# Access Compliance Report

## Public Rights-of-Way

### (Curb Ramps)

Intersection ID: 49151	Main Street: DACAVIN_DR	Cross Street: VIDAL_LN	Location: NE
ADA ID: BB4E29A72DAC	Ramp Type: Perp	Initial Pass/Fail: Fail	Overall Compliance: No
Severity Score: 33.75			
Codes/Mitigation Info/Possible Solution		Field Measurements/Component Compliance

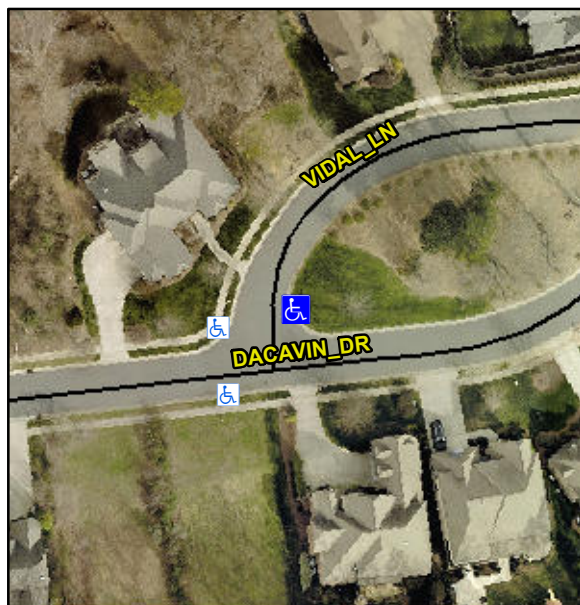
**Not Found, R304.5.1, R304.5.3**

Compliance	Description	Data	Compliance	Description	Data
N/A	Ramp Length (in)	48.0	Yes	Ramp Slope (%)	7.2
No	Ramp Width (in)	45.0	No	Ramp XSlope (%)	12.8
N/A	Flare Type LT	N/A	N/A	Flare Type RT	N/A
N/A	Flare Slope LT (%)	N/A	N/A	Flare Slope RT (%)	N/A
N/A	Flare Traversable LT?	N/A	N/A	Flare Traversable RT?	N/A
N/A	Landing Length (in)	N/A	N/A	DWS Provided?	N/A
N/A	Landing Width (in)	N/A	N/A	DWS Contrast?	N/A
N/A	Landing Slope (%)	N/A	N/A	DWS Length (in)	N/A
N/A	Landing X Slope (%)	N/A	N/A	DWS Full Width?	N/A
N/A	Landing Curb? (Y/N)	N/A	N/A	DWS Offset (in)	N/A
N/A	Shared Landing?	N/A			
N/A	Gutter Ponding?	N/A	N/A	Gutter Slope (%)	N/A
N/A	Gutter Lip Ht (in)	N/A	N/A	Gutter X Slope (%)	N/A
N/A	Painted X Walk1?	No	N/A	Painted X Walk2?	N/A
	X Walk 1 Direction	To W		X Walk 2 Direction	N/A
N/A	X Walk 1 Width (in)	N/A	N/A	X Walk 2 Width (in)	N/A
	X Walk 1 Slope (%)	3.8		X Walk 2 Slope (%)	N/A
	X Walk 1 X Slope (%)	8.5		X Walk 2 X Slope (%)	N/A

**Remove & Replace Entire Ramp.**
